Feedback on paving projects: STP PC20 (3), NH PC20 (4)

Document being referenced: [z18v188 z18v220 Composite Preliminary Plans.pdf](#)

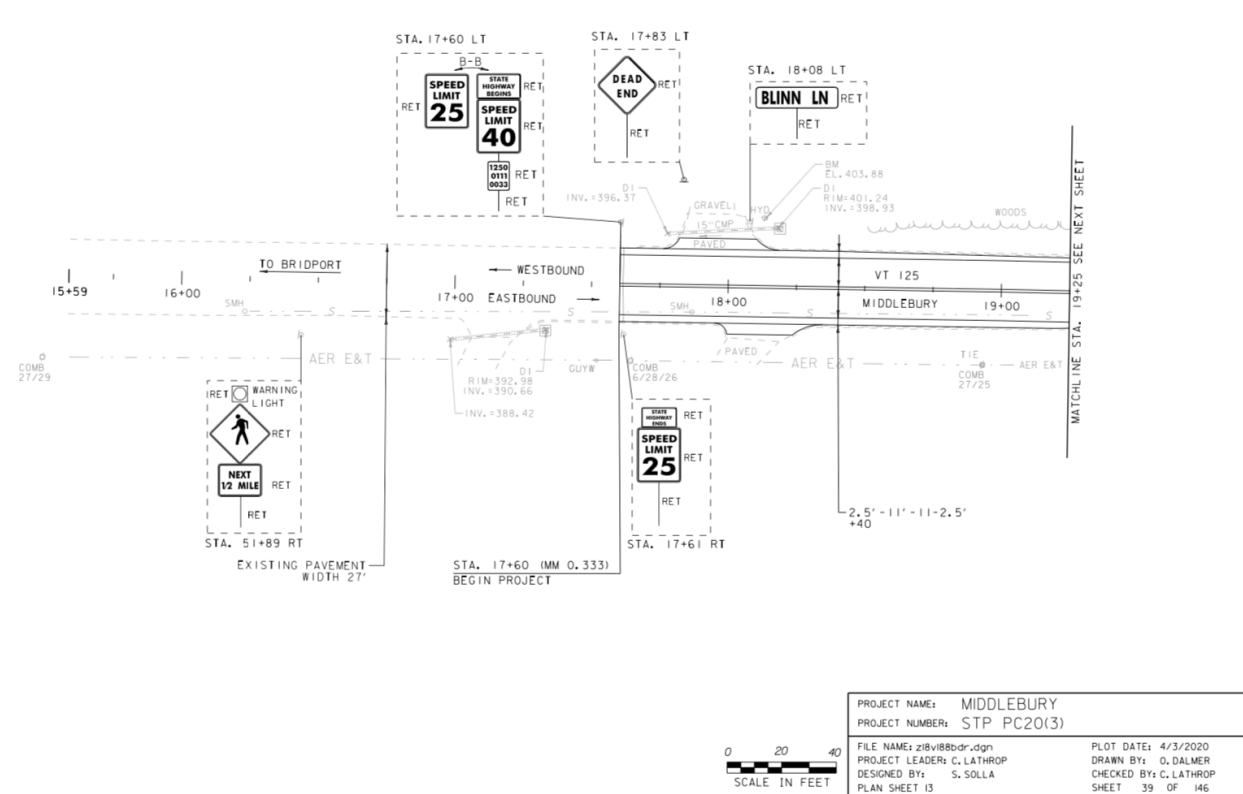
The draft plans show this as a 2.5'-11'-11'-2.5' cross-section (sheet 39). While this is an improvement on the current state of extra-wide travel-lanes and no shoulders, 2.5' is still not enough shoulder to be comfortable for uphill-bicycling or pedestrian use in either direction.

Biasing the centerline by 1.5 feet could provide a 1' wide shoulder on the westbound (downhill) side and a 4' shoulder on the eastbound (uphill) side, wide enough to be more usable by both bicycles and pedestrians.

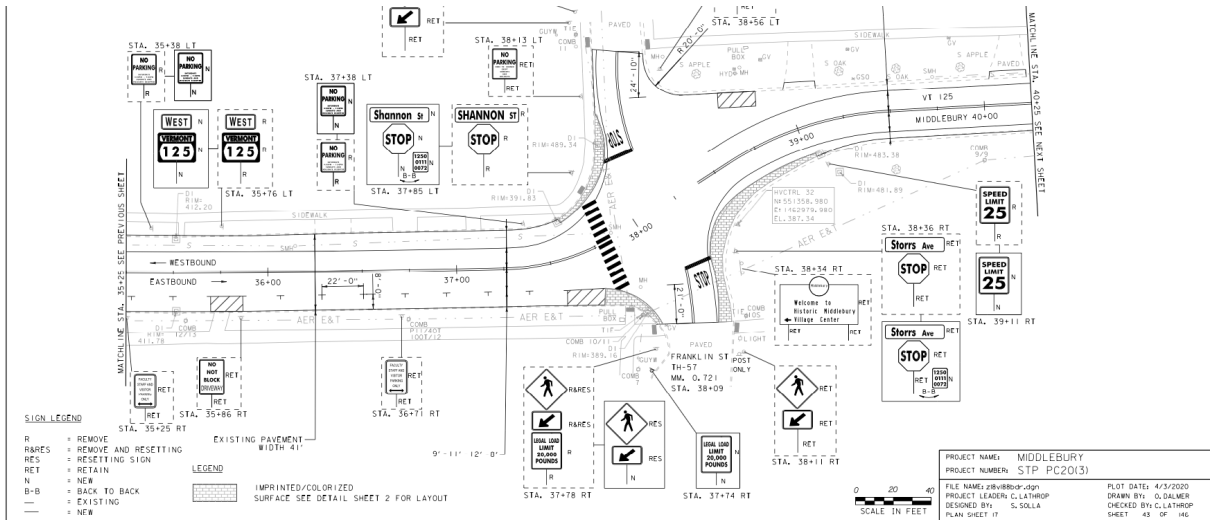
The 9' wide shoulder on the steep uphill in front of Saint Mary's (sheet 43) is great both for space for very slow-moving bicycles as well as to keep auto traffic constrained for calming purposes.

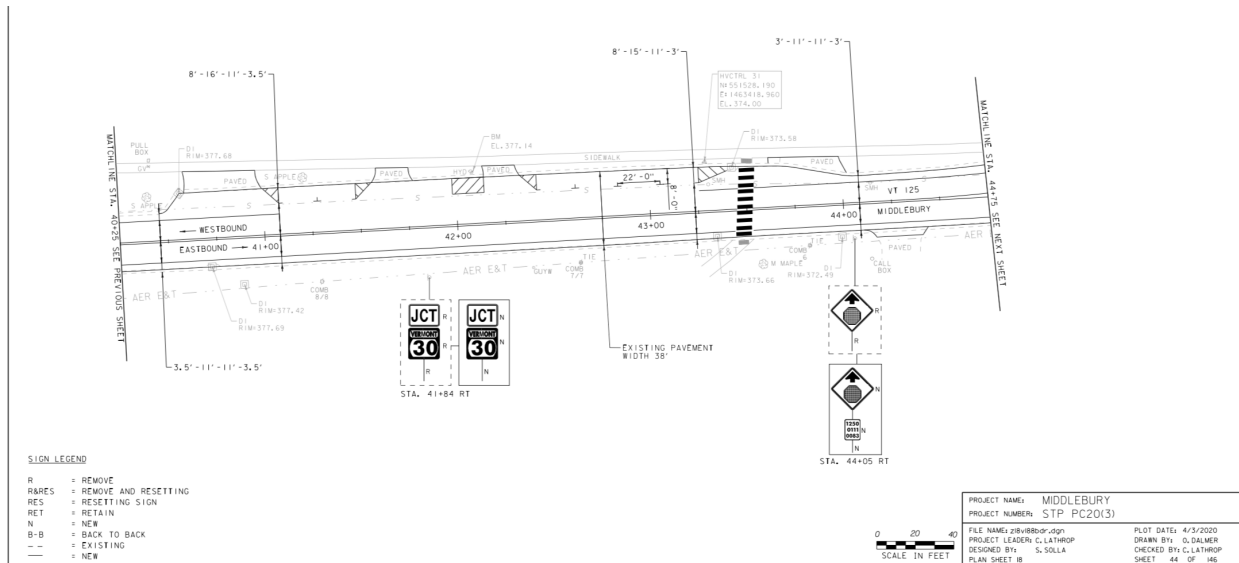
Sheet 44 shows the west-bound fog-line stopping for the mixed parallel parking/residential driveway segment. This opens up a 15'-16' space for the west-bound lane, reducing the effectiveness of lane-width as a traffic-calming measure as the roadway climbs uphill. Continuing to paint a fog-line in this section would help traffic calming and provide definition for a 4'-5' shoulder in an area where bicycles are climbing slowly.

Annotation of sheet 46.

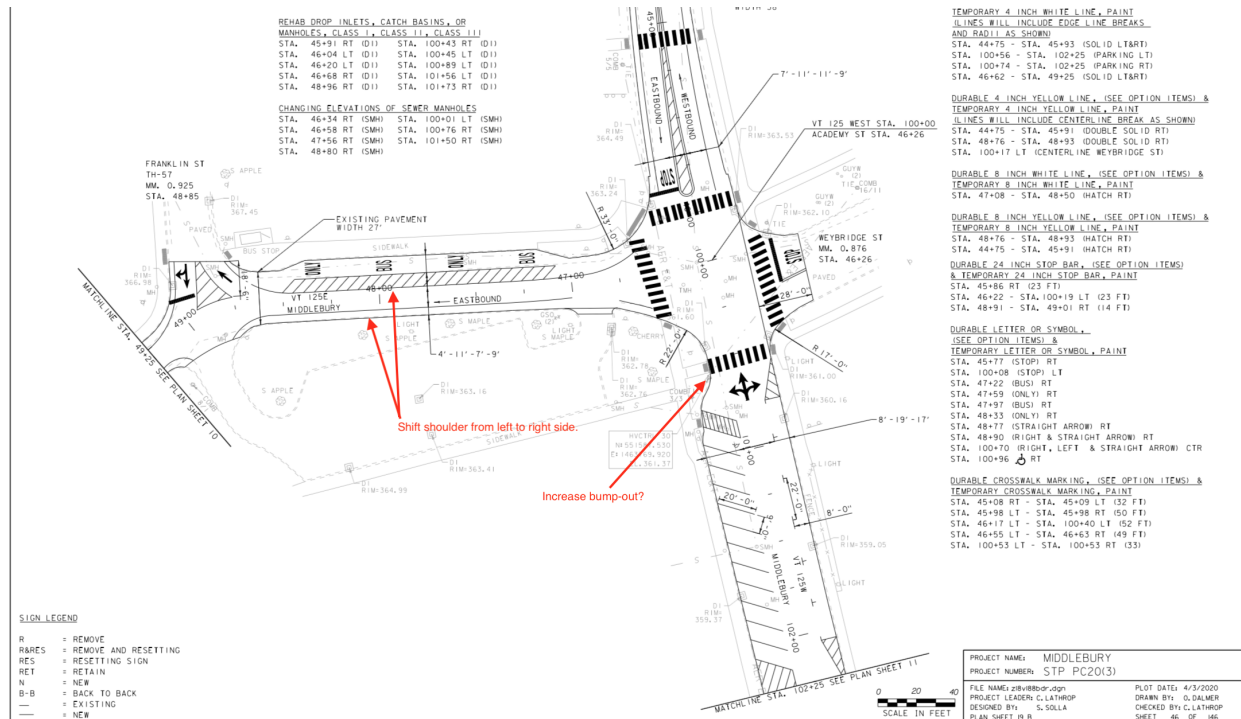
One of the often-voiced safety concerns of the College Street/Weybridge Street/Academy Street intersection is people on bikes (mostly reported as college-students) continuing eastbound

downhill straight onto the one-way section of College Street, against traffic. There are likely several reasons for this ill-advised behavior, but a few tweaks to this area could discourage it:

1. Increase the sidewalk bump-out to further discourage east-bound travel against traffic flow. This would also help shorten the crossing distance for pedestrians crossing from the park to Weybridge Street.
2. Improve the desirability of Academy Street as a bicycle route to downtown. This could be achieved by shifting the shoulder to the right side of Academy street and narrowing the bus buffer slightly to provide enough space for a full 5', signed/painted bicycle lane the length of Academy Street. Providing this attractive bicycle facility would go a long way toward encouraging prosocial behavior and not presenting eastbound students-on-bicycles with a host of unattractive options and hoping that they make a better choice.

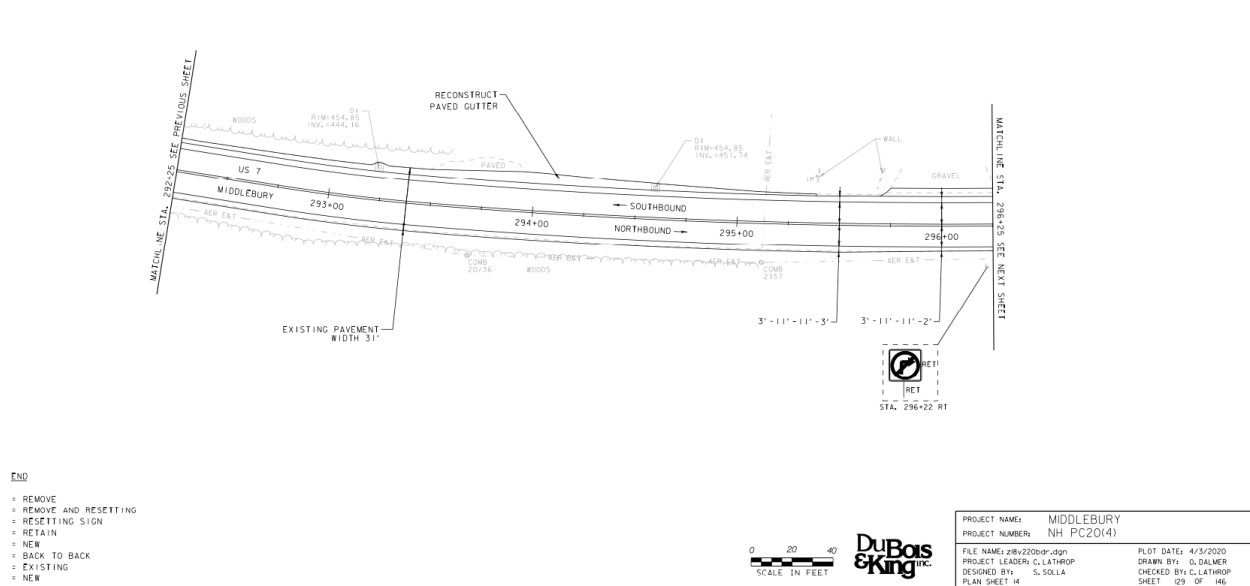
This intersection (sheet 84) was the subject of an intersection reconceptualization prepared by Alta Planning. The Middlebury Town Planner should have these concept plans. The crosswalk across Court Street is extremely wide and at the crest of the hill, making for a very long and
